I-15 LOGISTICS

FINAL ENVIRONMENTAL IMPACT REPORT

SCH No. 2018011008

May 14, 2020

Figure 1: South Coast AQMD Staff's Screenshot of Proposed Project's Line-Volume Truck Emission Sources in AERMOD

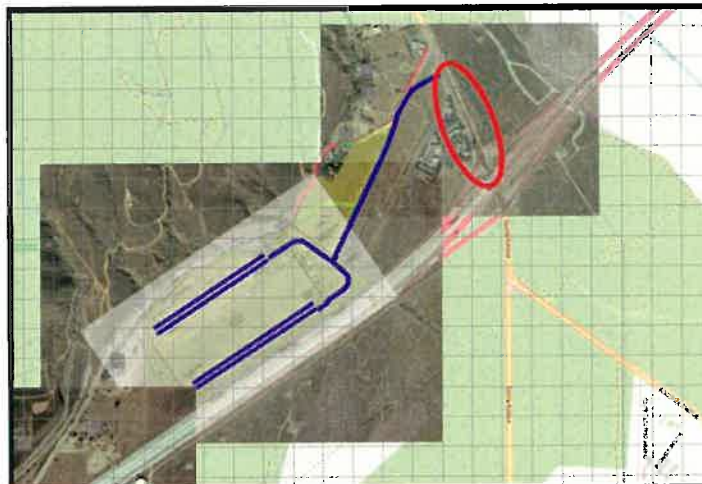
2. The Lead Agency used AERMOD to model the dispersion of the Proposed Project's emissions and perform a health risk assessment (HRA). In AERMOD, the Lead Agency modeled the dispersion of diesel particulate matter (DPM) emissions from heavy-duty trucks entering and exiting the Proposed Project, onsite travel, and trucks idling at the proposed dock doors. As illustrated in Figure 1, trucks entering and exiting the Proposed Project were modeled as a line-volume source from the Proposed Project's boundary to Sierra Avenue. However, it is recommended that mobile source emissions resulting from heavy-duty trucks visiting the Proposed Project be modeled to the nearest freeway on-/off-ramp. Therefore, South Coast AQMD staff recommends that the Lead Agency revise the air dispersion modeling to account for trucks traveling to and from the nearest freeway, in this case Interstate 15 (circled in red in Figure 1).

- 3-7 The commenter requests that the dispersion modeling and health risk assessment modeling be updated to include air dispersion modeling to and from the nearest freeway. The air dispersion modeling and health risk assessment (HRA) has been revised to include a line-volume source along Sierra Avenue to the nearest Interstate 15 (I-15) on-/off ramp. This addition allows the modeling to account for trucks traveling to and from the nearest freeway, I-15 in this case. This change is reflected in *I-15 Logistics Center Alternative – Health Risk Assessment Technical Memo* (HRA Memo), prepared by Michael Baker International, dated March 25, 2020; refer to Section 3.0. As concluded on Page 7 of the *I-15 Logistics Center Alternative – Health Risk Assessment Technical Memo* (HRA Memo) non-carcinogenic hazards resulting from the Proposed Project are calculated to be within acceptable limits; refer to Appendix B, of the Final EIR. Additionally, impacts related to cancer risk and PM₁₀ concentrations from warehouse operations would be less than significant at the nearest residential receptors and for workers. Therefore, impacts related to health risk from warehouse operations would be less than significant.
